**U.S. ENVIRONMENTAL PROTECTION AGENCY
REGION VIII WATER BRANCH, ENFORCEMENT
AND COMPLIANCE ASSURANCE DIVISION
CLEAN WATER ACT
COMPLIANCE INSPECTION REPORT**

Name of Facility: Suncor Energy (USA) Inc. Commerce City Refinery
Facility Address: 5801 Brighton Blvd., Commerce City, CO 80022
Mailing Address: 5801 Brighton Blvd., Commerce City, CO 80022

Type of Inspection:	Industrial Stormwater CEI
Owner:	Suncor Energy (USA) Inc.
Operator:	Suncor Energy (USA) Inc.
Permittee:	Suncor Energy (USA) Inc.
NPDES Permit No:	COS000009
NPDES Permit Effective Date:	September 27, 2012
NPDES Permit Expiration Date:	October 31, 2017 (administratively extended)
SIC Codes:	2911, 3599
Number of Outfalls:	9
Receiving Water:	Sand Creek; Unnamed tributary to the South Platte River
Latitude and Longitude:	39.75 N, -104.883333 W

Figure 1. SWA Nos. 1 and 2.

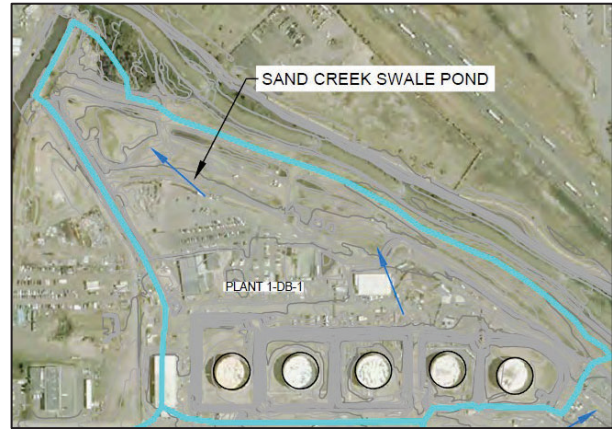
Stormwater runoff from SWA Nos. 1 and 2 (areas within Plant 1 where stormwater runoff is not treated by the WWTP; see Figure 1) is collected in the stormwater detention area upgradient of Outfall 023A (refer to [Appendix A, Photographs 6 and 13](#)). This stormwater detention area also receives runoff from the contaminated groundwater swale (referred to as the Sand Creek Swale Pond, see Figure 2) located between Plant 1 and Sand Creek during significant storm events (refer to [Appendix A, Photograph 12](#)). Additionally, stormwater runoff from an unnamed stormwater detention area located immediately east of the groundwater treatment systems (GWTS) (refer to [Appendix A, Photograph 11](#)) also drains to the stormwater detention area at Outfall 023A. Stormwater runoff from SWA No. 2 first collects in a concrete conveyance channel that runs north and northwest along the boundary of Plant 1 and adjacent to Metro Wastewater Reclamation District property and ultimately conveyed by culvert into the stormwater detention area at Outfall 023A.

Figure 4. SWA No. 8.

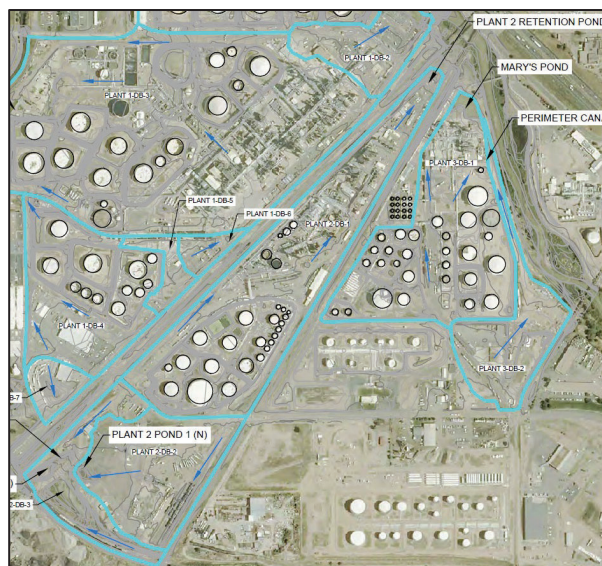
Runoff at Plant 2 generally flows north and northeast toward Sand Creek; however, the south side of Plant 2 drains to the south and southwest into an unnamed tributary to the South Platte that follows a railroad right-of-way to the west along the Facility's southern boundary (see Figure 5). Stormwater runoff from Plant 2 that is not captured (primarily employee parking area) by the oily water and non-oily water sewer systems collects in a stormwater detention basin located upgradient of Outfall 024A (refer to [Appendix A, Photograph 9](#)). According to Facility representatives, this basin is normally pumped back to the WWTP headworks for treatment but can discharge to Outfall 024A via gate valve, as needed.

Figure 6. SWA Nos. 6, 7, and 10.

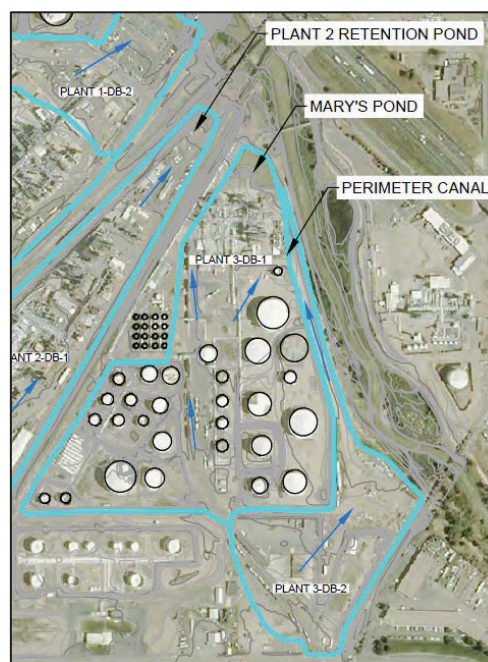
Runoff at Plant 3 generally flows to the north towards Mary's Pond or Sand Creek via the north entrance road (see Figure 7). During the inspection, Facility representatives explained that Outfall 027A, a manual release outfall associated with SWA No. 6, is no longer utilized for stormwater discharges. Stormwater runoff from Plant 3 is captured in Mary's Pond, a concrete lined stormwater retention basin. According to Facility representatives, during normal conditions, all stormwater runoff captured in this pond is pumped to the WWTP headworks for treatment (refer to [Appendix A, Photographs 22 and 23](#)). During significant storm events, Mary's Pond is discharged to Sand Creek through a manually controlled valve to Outfall 004A (refer to [Appendix A, Photograph 2](#)). During significant storm events, a concrete conveyance channel flowing northwest along the eastern perimeter of Plant 3 into Mary's Pond may overtop the channel wall upstream of the inlet into Mary's Pond. Stormwater that overtops this channel overland flows north into Sand Creek (refer to [Appendix A, Photograph 10](#)). This high flow contingency discharge point has been permitted by CDPHE as Outfall 026A.

Observation 4. During the inspection, the EPA Inspection Team observed a continual non-stormwater flow (i.e., cooling water) eroding the ground surface and causing sediment transport to flow into the open stormwater concrete conveyance channel along the east perimeter of
